AMENDMENTS TO THE DRAWINGS

REMARKS**Disposition of Claims**

FIG. 3E

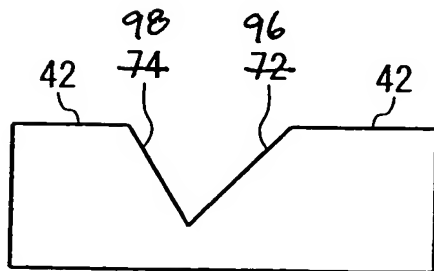
The drawings are objected to as failing to comply with 37 C.F.R. 1.84 (p) (5) because they do not include the following reference sign(s) mentioned in description: 96 and 98, The drawings have been amended in this reply in view of this objection. Accordingly, withdrawal of this objection is respectfully requested.

Please amend the figures as shown in the enclosed replacement sheets. The proposed changes include: adding an additional instance of reference numerals "96" and "98" to Figure 3E in place of reference numerals "72" and "74" respectively. No new matter is added in the substitute drawings.
